RE: Bloomfield Refining Company
#50 County Road 4990
Bloomfield, New Mexico
EPA ID No. NM089416416
Administrative Order on Consent - Docket No. VI-303-H
Response to USEPA Comments on the Draft RFI/CMS Report

**RESPONSE TO USEPA COMMENTS ON THE 11/08/94 DRAFT RFI/CMS REPORT
BLOOMFIELD REFINING COMPANY**

FIGURE 5

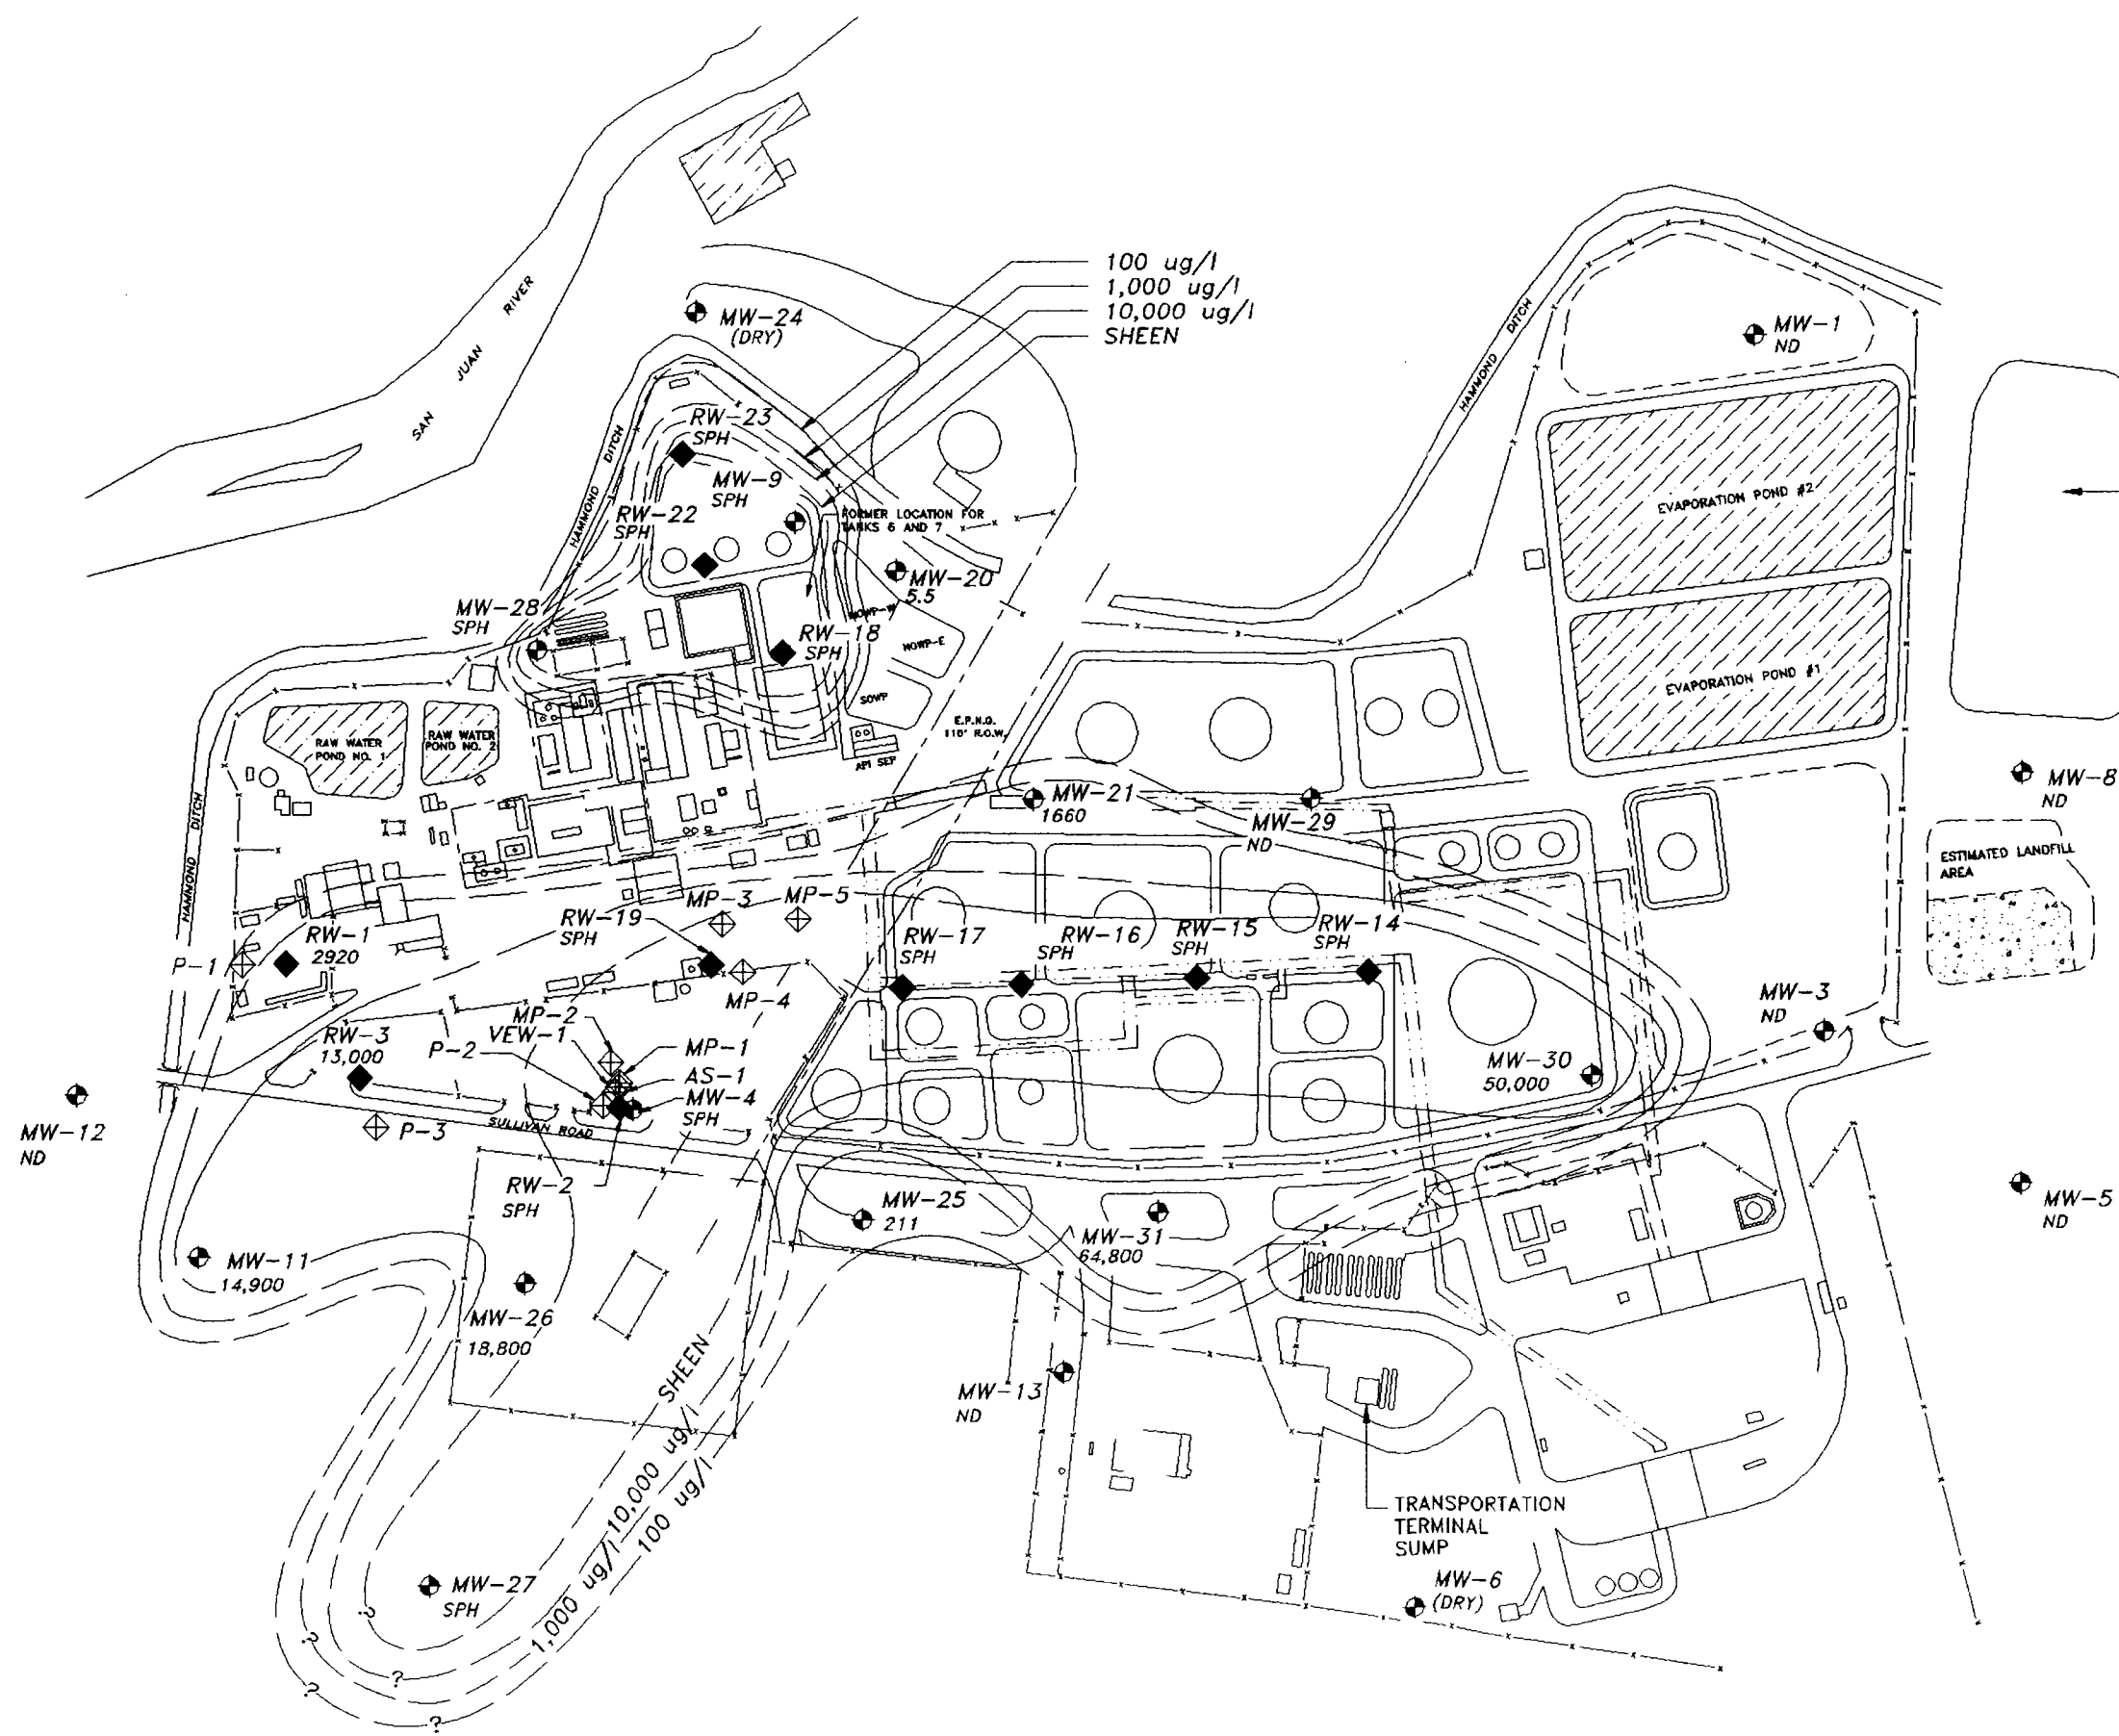
The draft RFI report does not contain any thickness maps showing the limits of groundwater contamination. These maps must be compiled to show the limits of groundwater contamination across the facility as well as off-site.

Figures 4, 5, 6, 7, 8, 9, and 10 depict the extent of SPH, total targeted volatile organics, and total targeted semi-volatile organics, based on the May 24-25, 1994 monitoring data and the August 3-4, 1994 monitoring data. The maps show two main areas of hydrocarbon contamination. Dissolved hydrocarbon and SPH plumes are present along much of the south side of the facility extending southwest along the El Paso Natural Gas pipeline. The levels of SPH in this area are currently controlled by a number of recovery wells. Three additional monitor wells have been installed southwest of the site and plume definition is essentially completed with these wells (the results will be forwarded to USEPA before 1 May 1995). In the northwest corner of the site, another area of hydrocarbon contamination is present. In this area, a thin accumulation of SPH has been identified.

DESIGNED BY:	DRAFTED BY:	CHECKED BY:	
RS	PJWH		
DATE:	FILE:		
04/05/95	3014BL (1:100)		
PROJECT NO.:	CONTRACT:		
023353014			
DRAWING:	REVISION:		
<p align="center">FIGURE 10</p>

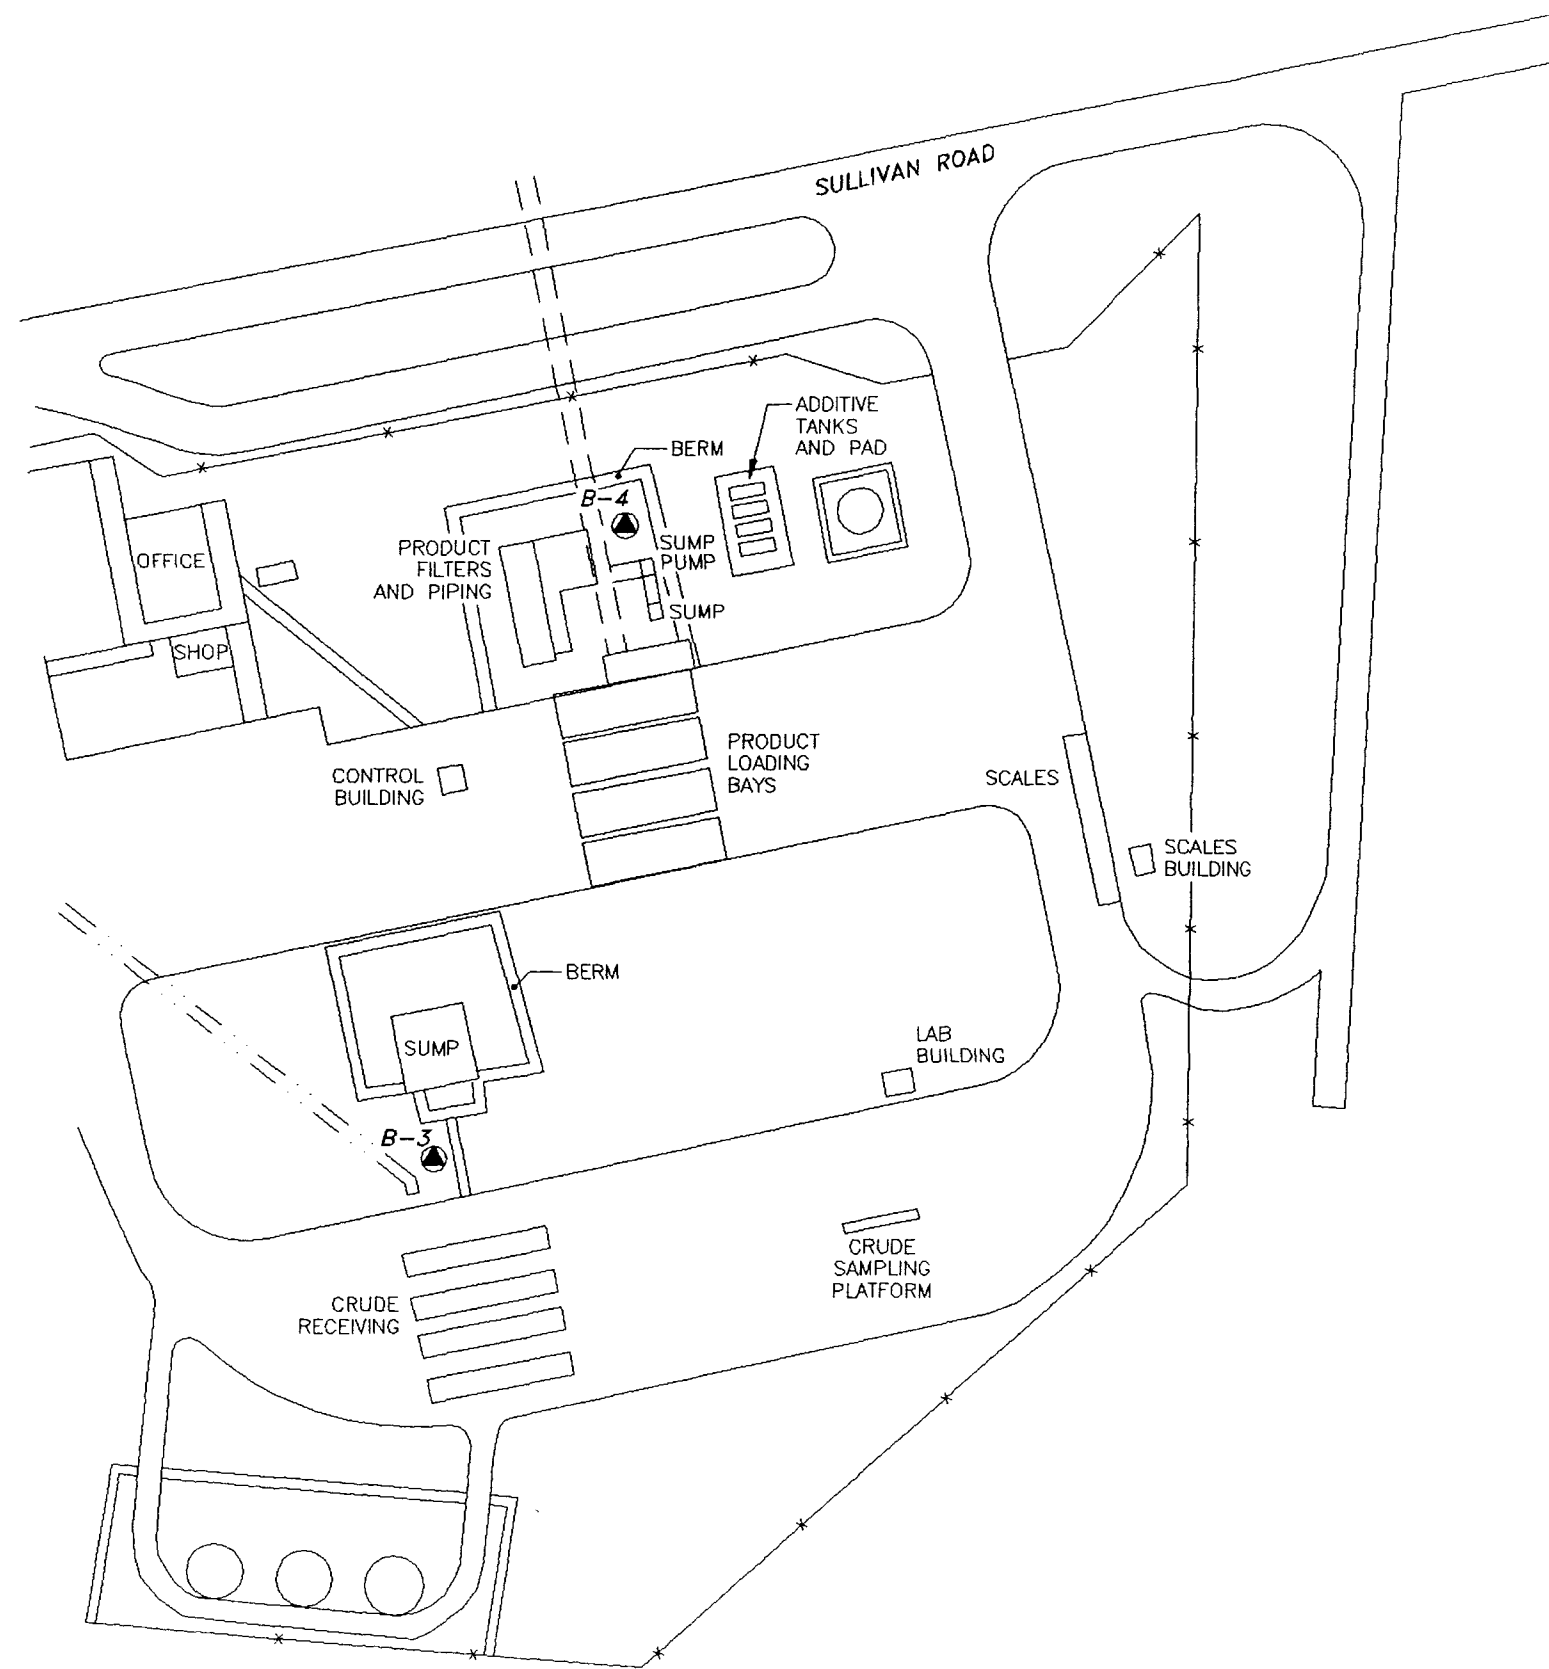
These concentrations indicate that there has been a release to the environment. The full extent of the release must be therefore delineated. The location of the two borings with respect to the loading operations must be presented in greater detail. Are the two borings near the loading area, or are they located near the boundary of this SWMU? Additional information will be required in this area prior to determining no further action. The rationale for not fully delineating the release from this SWMU must be presented.

Response: Figure 10 shows the locations of soil borings B-3 and B-4. Soil boring B-4 is located near the sump pump approximately 50 feet from the product loading bays (the most likely location of a release). Soil boring B-3 is located within 50 feet the crude oil receiving area and the pipeline that extends from this area. Had significant releases occurred in these areas, the borings would have detected some evidence of these releases. Instead, the hydrocarbon concentrations in this area are near method detection limits and unlikely to represent a threat to groundwater through leaching. The hydrocarbon levels in the samples collected from B-3 and B-4 are believed to be the cumulative affect of product handling/ incidental spillage in this area and do not suggest that additional assessment is needed in this area.

DESIGNED BY: CD	DETAILED BY: EF	CHECKED BY:
DATE:	FILE: BL-WELL LOC	
PROJECT NO.: 023353014	CONTRACT:	
DRAWING: FIGURE //	REVISION:

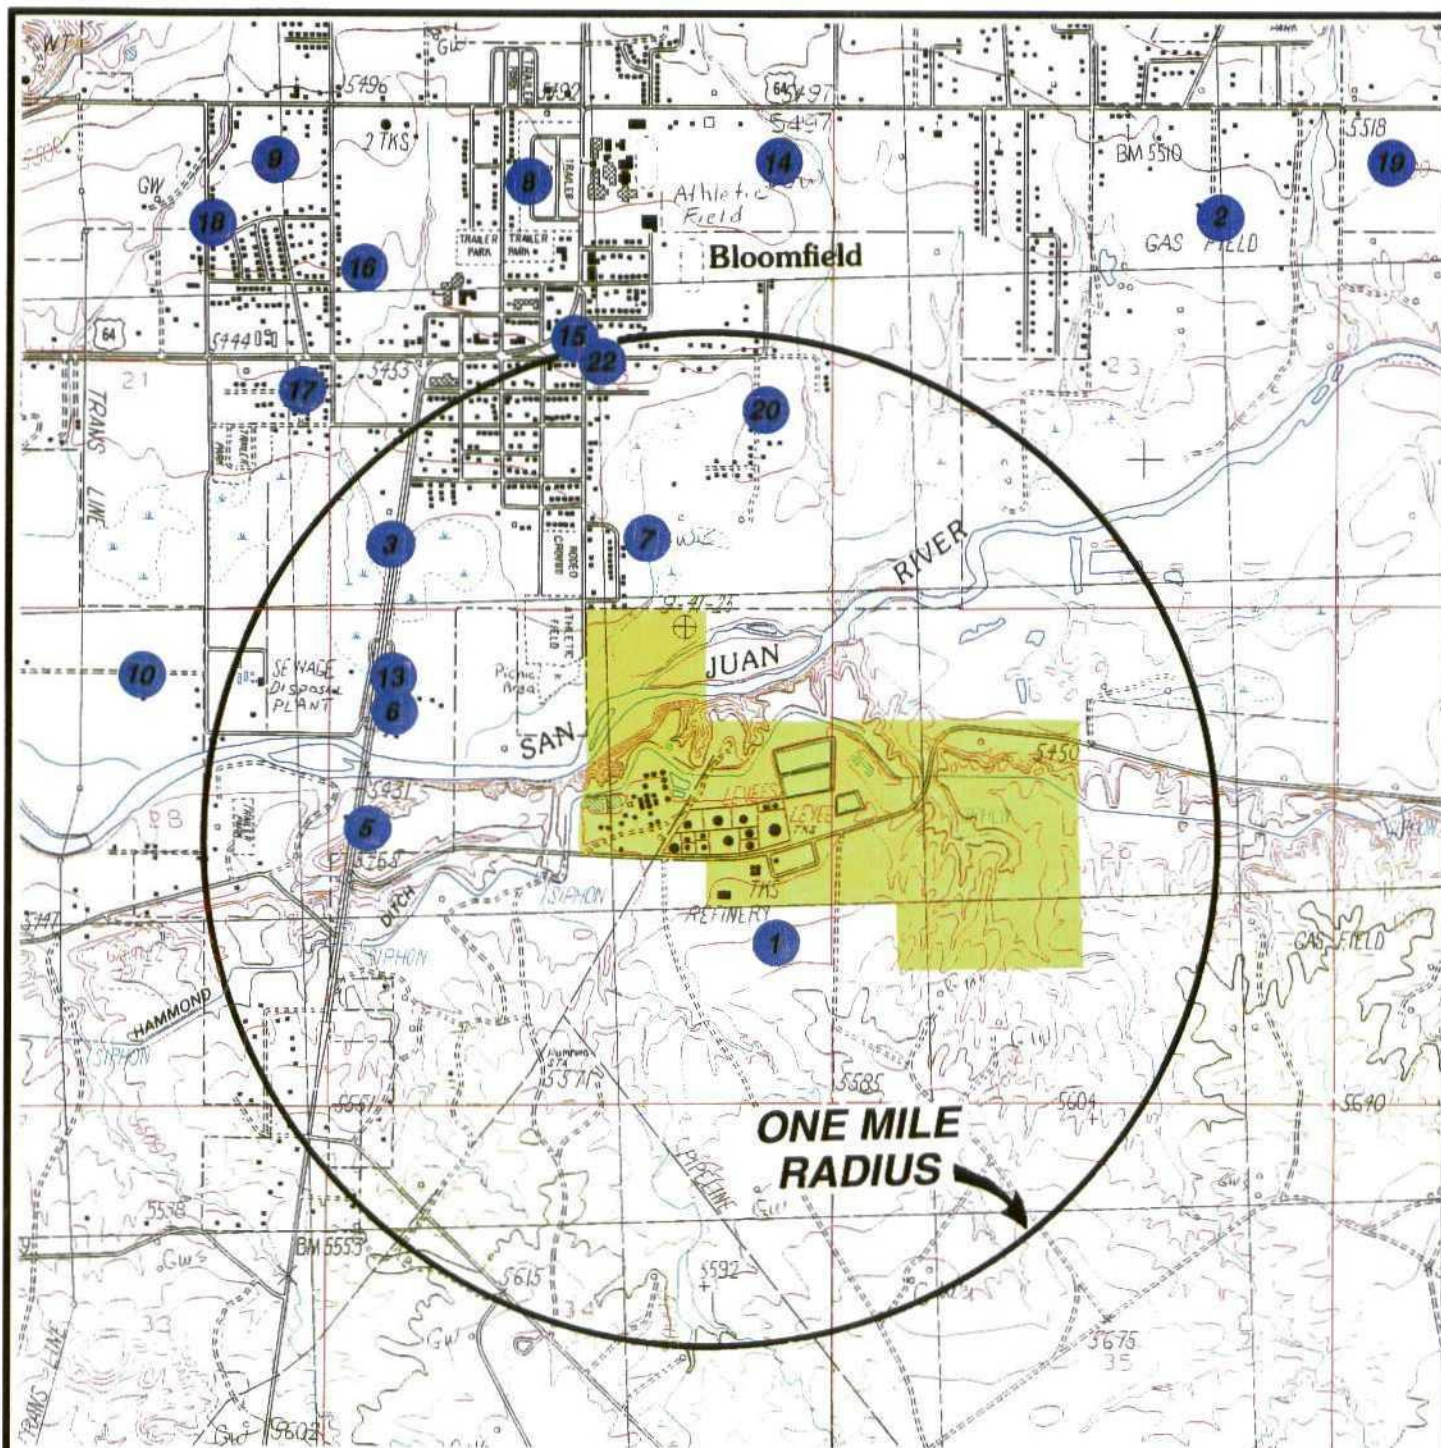
According to the draft RFI report, two off-site private wells (Looney well and Brown well) are located downgradient of the facility in the shallow aquifer. The RFI report does not provide any information on the water quality of the off-site wells. Have either of these wells been sampled to determine if they have been impacted by facility operations? Additional information on these two wells must be provided in the RFI report.

Response: Figure 11 in this submittal shows the revised water well locations within a one mile radius of the BRC facility using the New Mexico township-range-section coordinate system. Well locations were incorrectly plotted in the original RFI report. Copies of the well logs are provided in Attachment D. As shown on the revised map, the Brown well (#5) is located on the north side of Hammond Ditch near Highway 44, more than 2,000 feet from the southwesternmost corner of the BRC facility. The Looney well (#6) is located north of the San Juan River, also near Highway 44. The revised, correct locations of these wells indicate that they are not at risk of hydrocarbon contamination from the BRC facility.

Well Log for MW-12

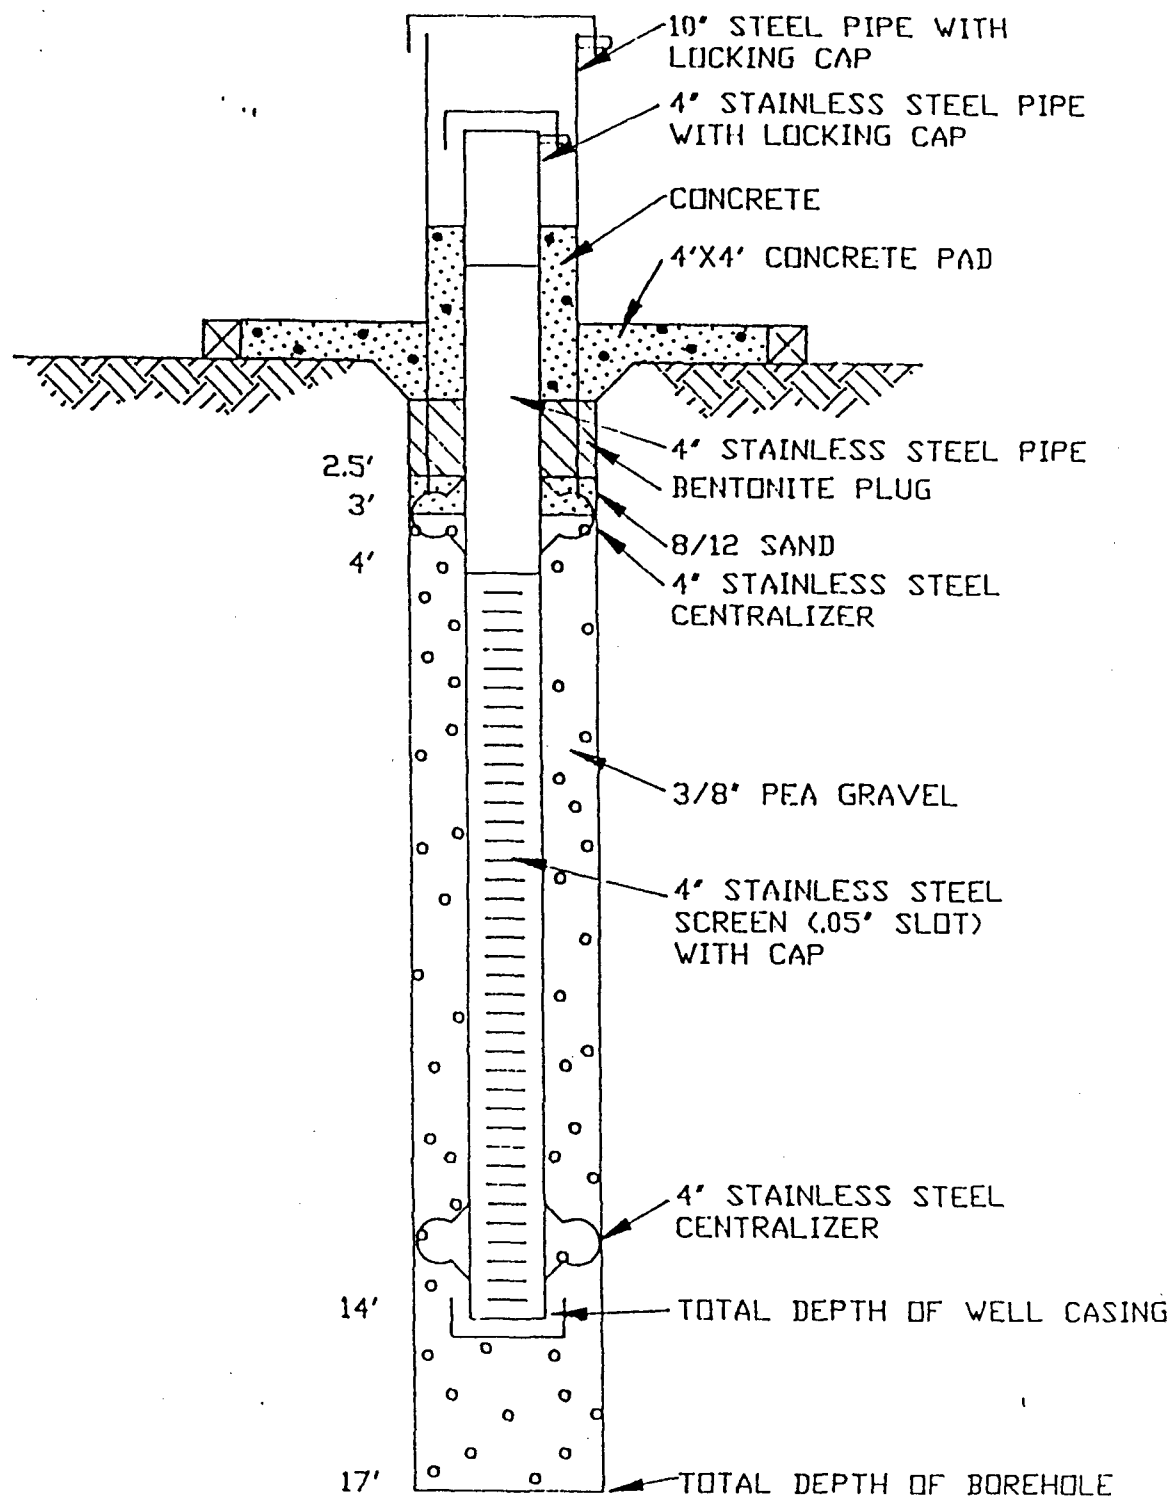
The potentiometric level in monitoring well MW-12 is approximately 10 feet below the potentiometric level in the nearest well. The draft RFI report does not discuss or explain the reasons for this extreme difference in the water levels. Is this well monitoring a different water-bearing strata? If so, which aquifer? A discussion on monitoring well MW-12 must be provided in the RFI report.

Response: Attachment B contains a copy of the well log for monitoring well MW-12. Well MW-12 is a relatively shallow well. The borehole extended to 17 feet and the screen was installed from 4 to 14 feet which extends to the top of the Nacimiento Formation. The elevation

of the top of bedrock in this area is approximately 8 feet lower than in nearby monitoring well MW-11. Since the perched aquifer follows the bedrock contour, groundwater elevations are also lower in this area than in other site wells.
